Access Compliance Report

Public Rights-of-Way

Intersection ID: 32056	Main Street: AZALEA RIDGE RD	Cross Street: PROVIDENCE RD	Location: NW
ADA ID: FA3C251AAC98	Ramp Type: PerpDiag	Initial Pass/Fail: Fail	Overall Compliance: No
Severity Score: 22.5			
Codes/Mitigation Info/Possible Solution		Field Measurements/Component Compliance

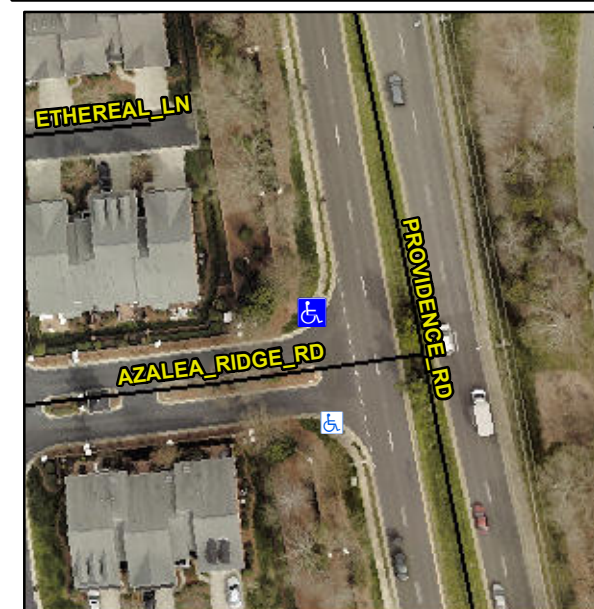
Not Found, R304.5.1, R304.2.2, R304.5.3

Compliance	Description	Data	Compliance	Description	Data
N/A	Ramp Length (in)	81.0	No	Ramp Slope (%)	8.9
No	Ramp Width (in)	38.0	No	Ramp XSlope (%)	3.9
N/A	Flare Type LT	N/A	N/A	Flare Type RT	N/A
N/A	Flare Slope LT (%)	N/A	N/A	Flare Slope RT (%)	N/A
N/A	Flare Traversable LT?	N/A	N/A	Flare Traversable RT?	N/A
N/A	Landing Length (in)	N/A	N/A	DWS Provided?	N/A
N/A	Landing Width (in)	N/A	N/A	DWS Contrast?	N/A
N/A	Landing Slope (%)	N/A	N/A	DWS Length (in)	N/A
N/A	Landing X Slope (%)	N/A	N/A	DWS Full Width?	N/A
N/A	Landing Curb? (Y/N)	N/A	N/A	DWS Offset (in)	N/A
N/A	Shared Landing?	N/A			
N/A	Gutter Ponding?	N/A	N/A	Gutter Slope (%)	N/A
N/A	Gutter Lip Ht (in)	N/A	N/A	Gutter X Slope (%)	N/A
N/A	Painted X Walk1?	No	N/A	Painted X Walk2?	No
	X Walk 1 Direction	To S		X Walk 2 Direction	To E
N/A	X Walk 1 Width (in)	N/A	N/A	X Walk 2 Width (in)	N/A
	X Walk 1 Slope (%)	0.9		X Walk 2 Slope (%)	2.4
	X Walk 1 X Slope (%)	4.4		X Walk 2 X Slope (%)	1.5

Remove & Replace Curb Ramp With Two New Directional Ramps or Equivalent.
